Remarks/Arguments

Application No. 10/551,852
Amdt. Dated: July 29, 2007
Reply to Office Action Dated: May 29, 2007

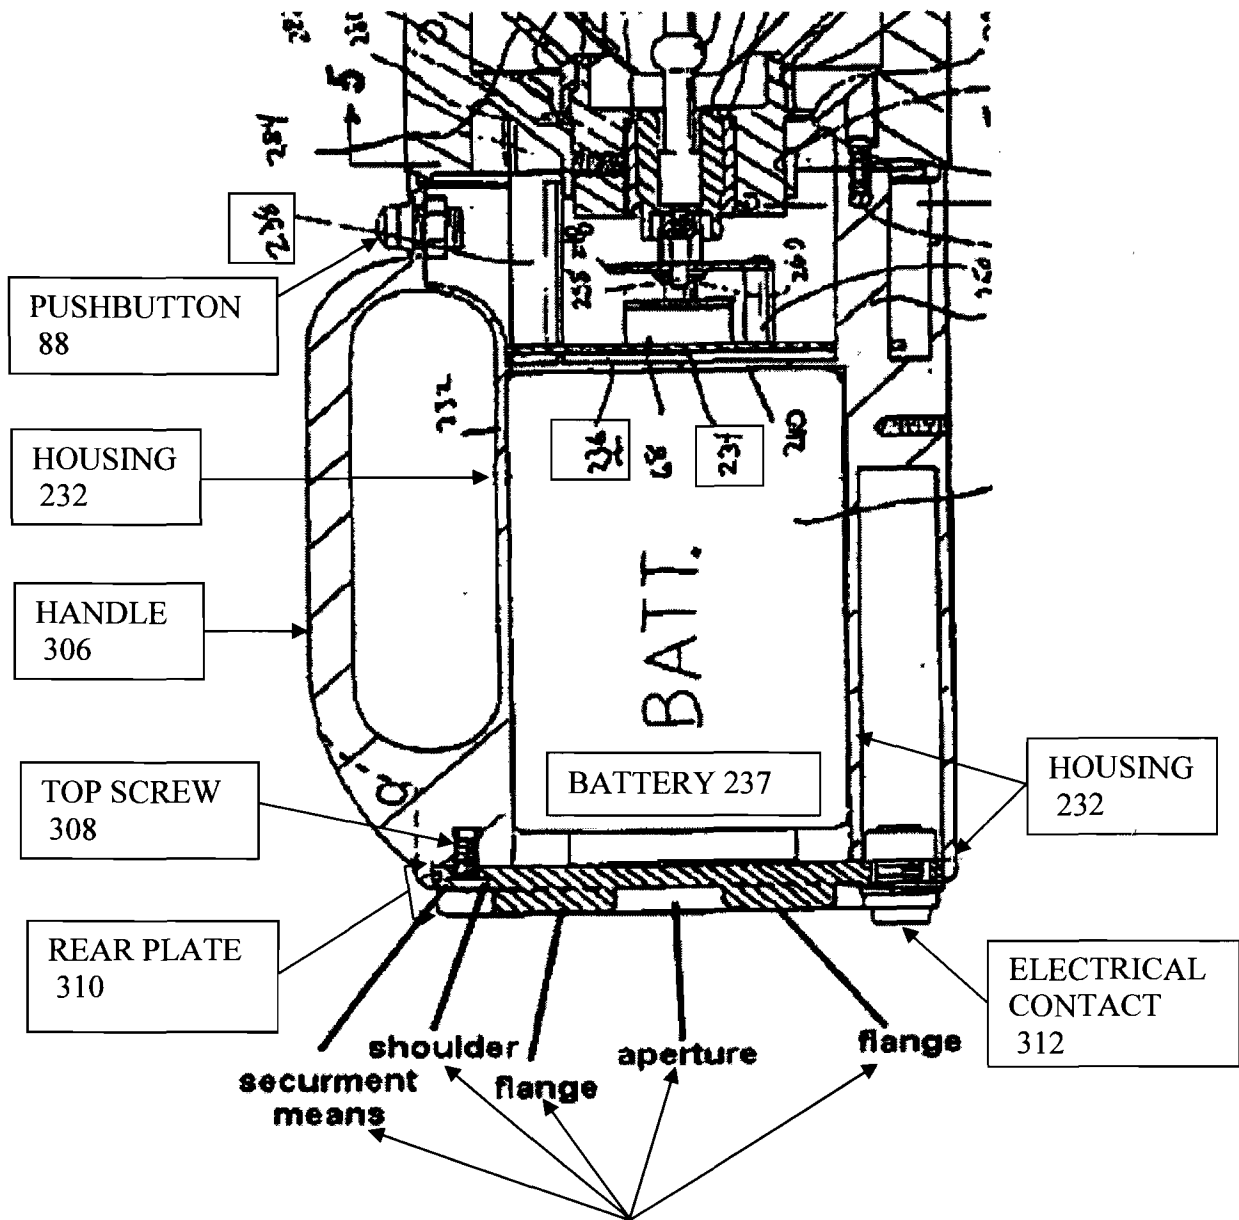
The drawings are objected to because the flange and the shoulder are not clearly shown in the drawings. Applicant traverses this objection as the flange 156 and the shoulder 162 are clearly shown and referenced in FIG. 10. However, to expedite prosecution, a new figure showing the flange and the shoulder has been added. Attached herewith is a replacement sheet of drawings including new figure, FIG. 10B, which provides an enlarged view of the subject elements without surrounding detail. The magnified view includes a portion of FIG. 10 (now FIG. 10A), which is an enlarged view of the detail X in FIG. 9. No new matter has been added. It is believed that FIG. 10B clearly shows the flange and the shoulder. Accordingly, this objection should be withdrawn.

A non-limiting example illustrating the elements recited in claim 31 is illustrated in Figs. 10A and 10B. As shown in Figs. 10A and 10B, the electrical contact 152 extends from inside the flashlight housing 166 (first end portion 158) through an electrical contact aperture 38 in the flashlight housing 166 being disposed partly outside the flashlight housing 166 (second end portion 154) and includes a flange 156 located outside of the flashlight housing 166 that provides a shoulder 162 adjacent the flashlight housing 166. A resilient sealing means 164 is sandwiched between the shoulder 162 and the flashlight housing 166 to establish a water tight seal between the shoulder 162 and the flashlight housing 166.

Figs. 10A and 10B further shows that flashlight 10 includes a contact connection means 158 for connecting the flashlight electrical contact 152 to the flashlight housing 166. The contact connection means 158 extends from the flashlight electrical contact 154 through the contact aperture 38 and includes securement means 168 that secures the contact connection means 158 in relation to the flashlight housing 166 such that the shoulder 162 maintains the sealing means under compression. In Fig. 10, the end portion 158 is shown in an undeformed state. To complete the securement of the contact 152 with the housing 166, the end portion 158 is deformed outwardly so that it is rolled downwards so as to press against the securement means 168, which places the electrical contact 152 under compression, urging the shoulder 162 upwardly to compress the sealing means 164.

Annotated Fig. 2 of Jigamian et al.
showing a cross sectional view of the searchlight 11

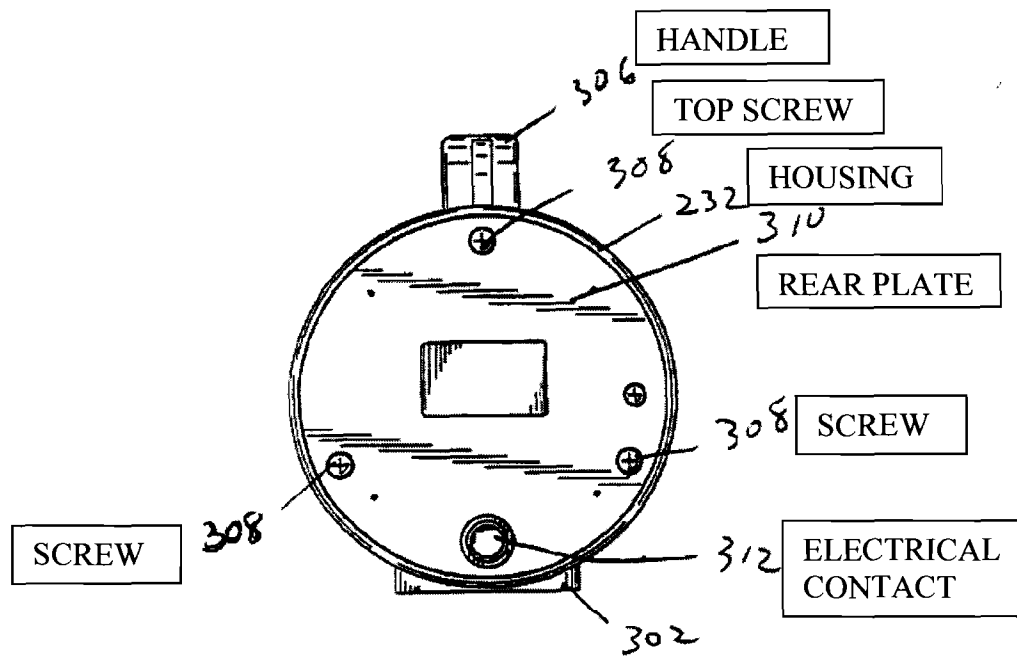
The Office asserts the combination of Jigamian et al. and Groben teaches all the limitations of claim 31. The Office has included an annotated Fig. 2 of Jimagian et al. showing what the Office alleges to be structure that identifies the claimed elements in the subject Office Action. Fig. 1b of Jimagian and the annotated copy of Fig. 2 of Jimagian are provided below and discussed in connection with this rejection.

Claim 31 requires that the flashlight housing define an electrical contact aperture and that an electrical contact extend from inside the housing through the aperture being disposed partly outside the flashlight housing and include a flange located outside of the housing that provides a shoulder adjacent the housing. The Office asserts that electrical contact 312 of Jagamian et al. teaches the claimed electrical contact.

On page 10 of the Office Action, the Office asserts that the hole where pushbutton switch 88 connects to the housing 232 of the searchlight 11 teaches the claimed electrical contact aperture opening defined by the housing, and on page 12 of the Office Action the Office identifies, in annotated Fig. 2, a recess in the rear plate 310 as the claimed electrical contact aperture opening. The Office further identifies, in annotated Fig. 2, portions of the rear plate 310 as the claimed flange of the electrical contact. However, as clearly shown in annotated Fig. 2 and Fig. 1b above the electrical connector 312 neither

extends through the hole where pushbutton switch 88 connects to the housing 232 nor through the recess in the rear plate 310, and the portions of the rear plate 310 are not flanges of the electrical contact 310.

In addition, neither Jagimian et al. nor Groben teach or suggest an electrical contact that includes a flange located outside of the housing that provides a shoulder adjacent the housing. On page 10 of the Office Action, the Office identifies a portion of the rear plate 310 as the electrical contact flange. However, this portion of the rear plate 310 is not part of the electrical contact 312 and, thus, the electrical contact 312 does not include it. Rather, this portion of the rear plate 310 and the electrical contact 312 are separate and distinct structures. As such, the electrical contact 312 does not include a flange that provides a shoulder adjacent to the housing as recited in claim 31.
